RE: ADDENDUM NO. 1
For RFCSP NO. 2021-229-05-05-JDC
“Construction of New Justice Center – PCT. 4”

ADDENDUM NO. 1

RFCSP NO. 2021-229-05-05-JDC
“Construction of New Justice Center – PCT.4”

ENLARGED
MECHANICAL YARD /
ELEV. / DETAILS

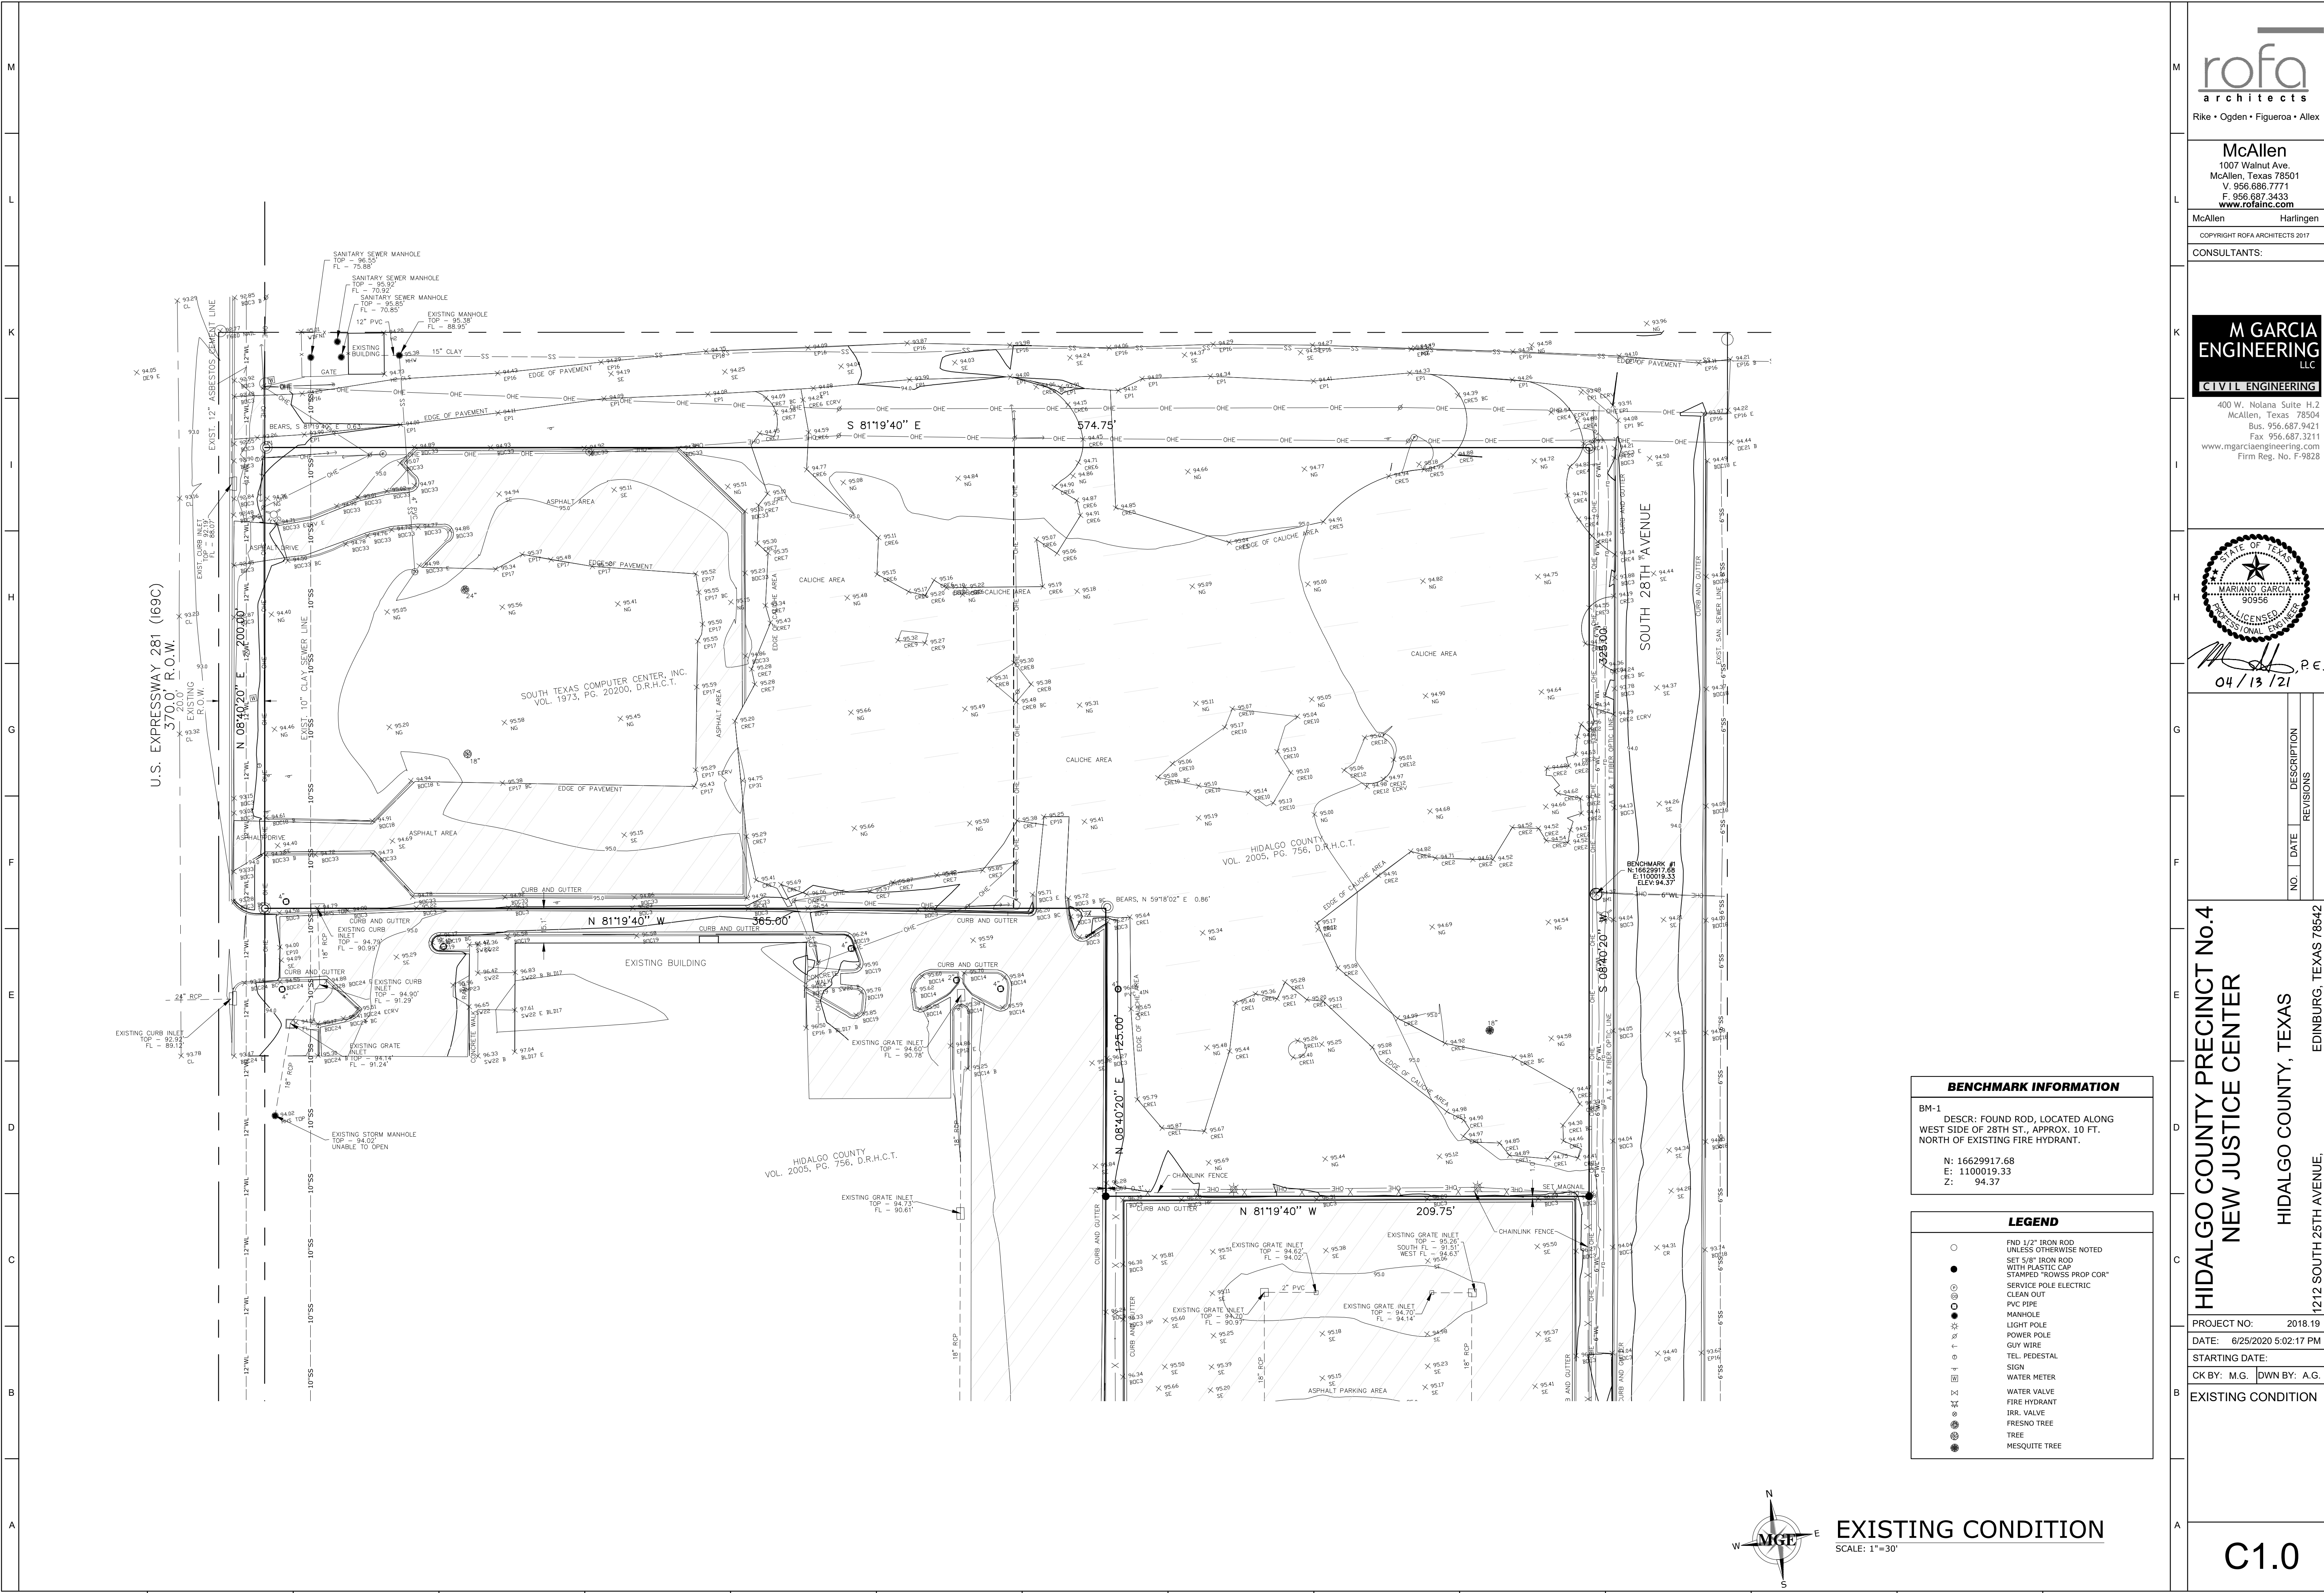
ITEM NO. 16 : ARCHITECTURAL SITE PLAN CHANGES

Per the attached Sheet AS1.1, AS1.2, AS1.3 & AS1.4 please find Architectural Site Plan Changes.
